Item ID: D119-646-141 **Accept** ***N900040100*** **Setup Start *NS1***
Revision ID: URF 15-560 **Stop *NS2***
Item Name: AW119 Replacement Skidtube with Standard Wearplates & Wearpads, Fits LH & RH
Start Date: 2/1/2017 **Start Qty:** 1.00 ***1*** **Cust Item ID:**
Required Date: 2/8/2017 **Req'd Qty:** 1.00 ***1*** **Customer:**
Reference:

DESIGN	RF	DART AEROSPACE USA, INC.	
DRAWN	DB	KENT, WA	
CHECKED		DRAWING NO.	REV. D
MFG. APPR.		D3887	SHEET 2 OF 8
APPROVED		TITLE	SCALE
DE APPR.		A119 STD SKIDTUBE ASSY	NTS
DATE	13.09.20	COPYRIGHT © 2000 BY DART AEROSPACE USA, INC. THIS DOCUMENT IS UNCLASSIFIED AND IS RELEASED ON THE EXPRESS CONDITION THAT IT IS NOT TO BE USED FOR ANY PURPOSE OR COMMERCE OR COMPARED TO ANY OTHER PERSON WITHOUT WRITTEN PERMISSION FROM DART AEROSPACE USA, INC.

DRAWING NO. D3887	TITLE A119 STD SKIDTUBE ASSY	REV. D	DART AEROSPACE USA, INC. ENGINEERING ORDER		D.E.O. NO. D3887-D-1	SHEET NO. SHEET 1 OF 3	SCALE NTS
DRAWN AJS		CHECKED		MFG. APPR.	APPROVED	DE APPR.	
DATE 16.11.08		DATE		DATE	DATE	DATE

SHEET 2: (1) ADD DETAIL H
(2) UPDATE PLUGGING FASTENERS AS SHOWN:

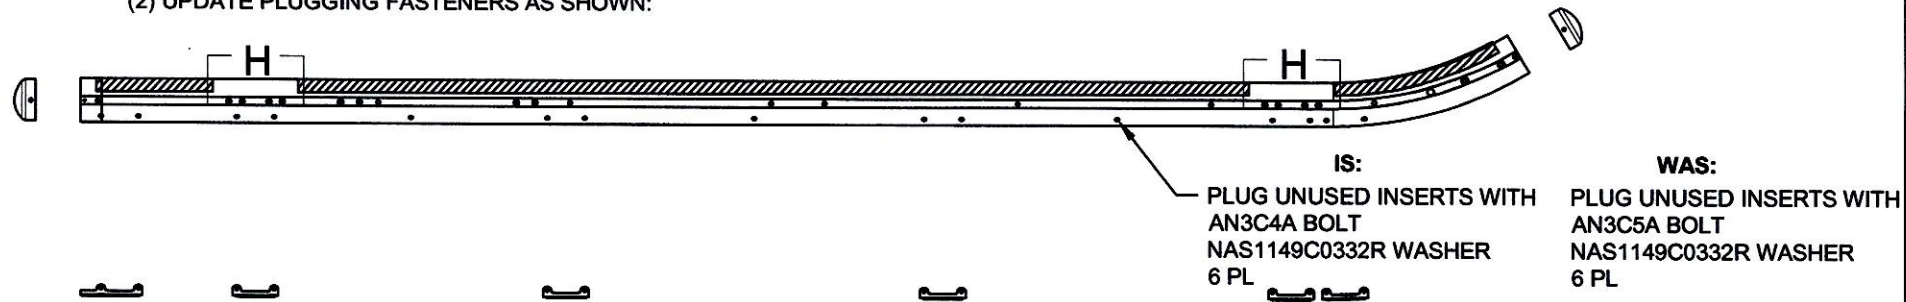
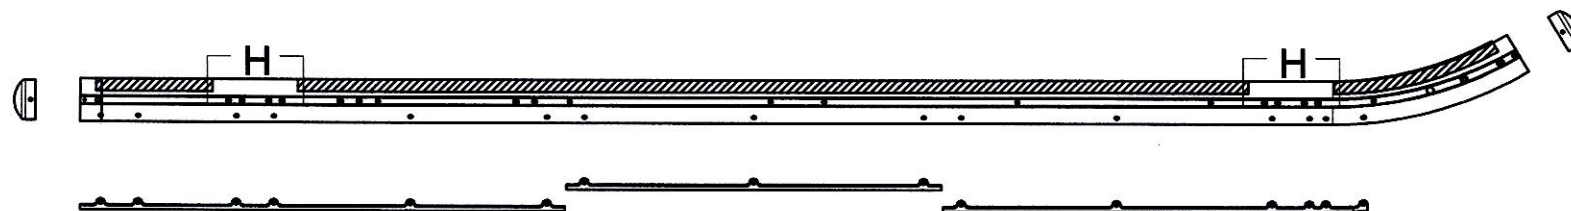
D3887-041 STANDARD SKIDTUBE ASSY WITH WEARPAD

SHEETS 3 AND 4 ADD DETAIL H

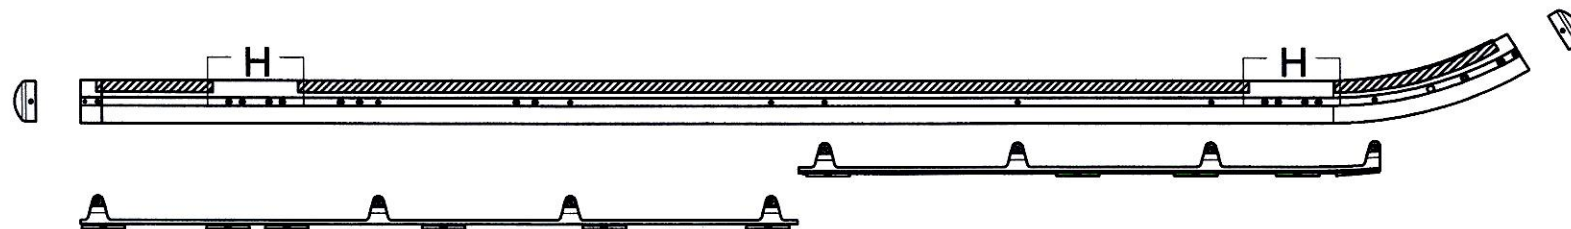
D3887-043 STANDARD SKIDTUBE ASSY WITH WEARPLATE

DETAIL H

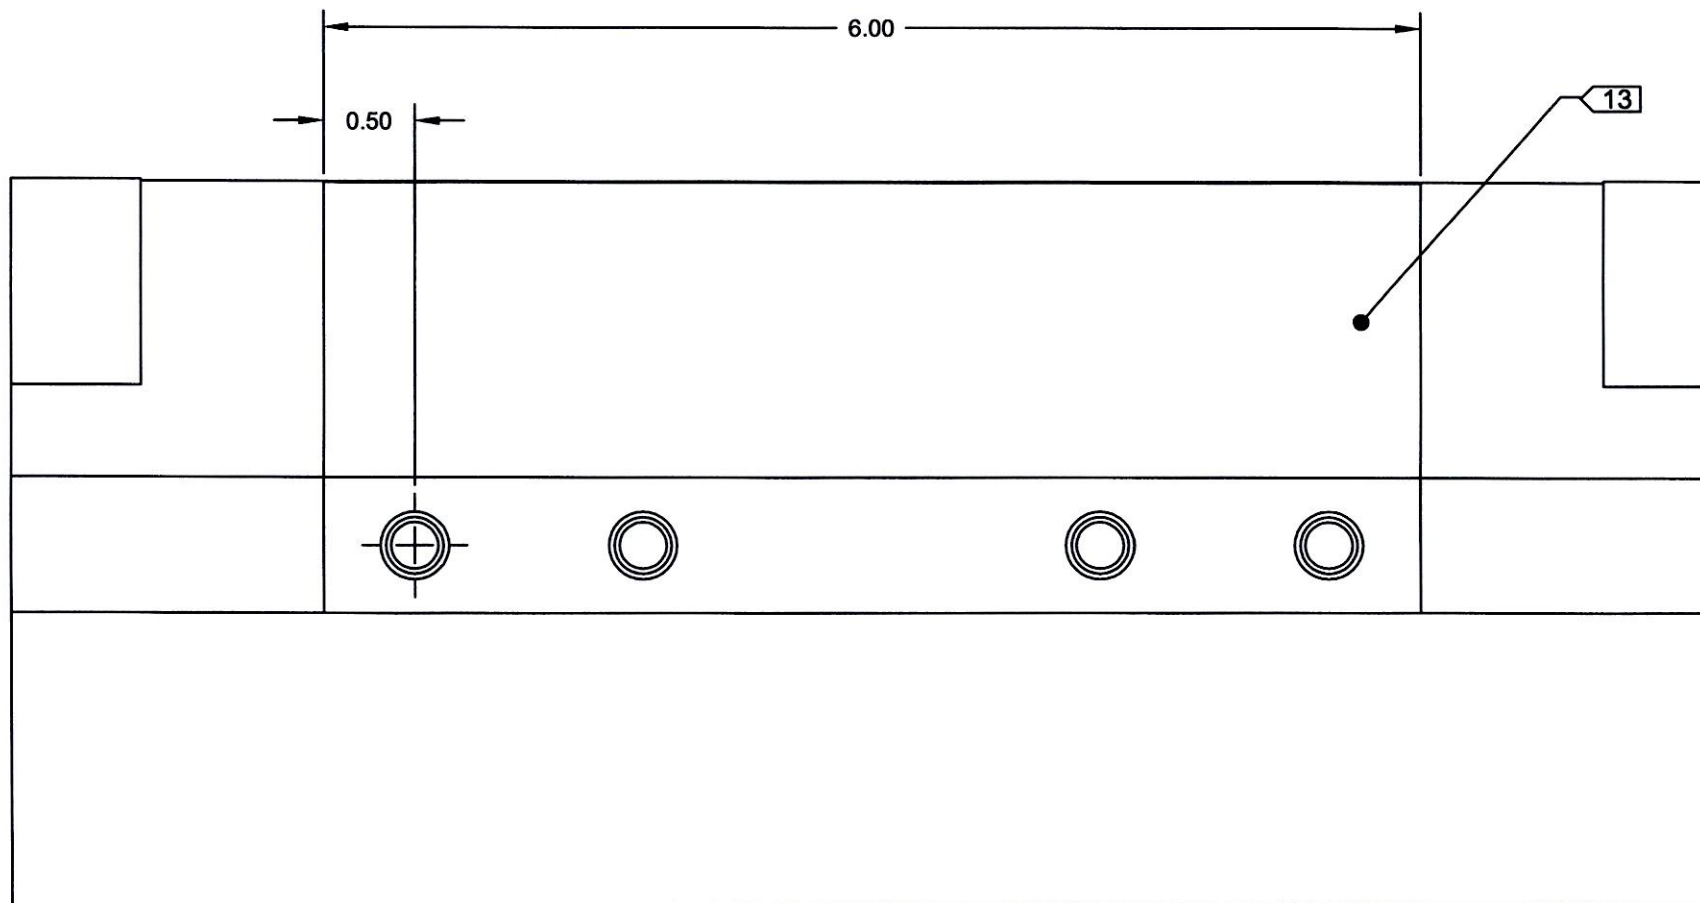
SHEET 7 ADD DETAIL H TO THE FACE OF DRAWING AS SHOWN:
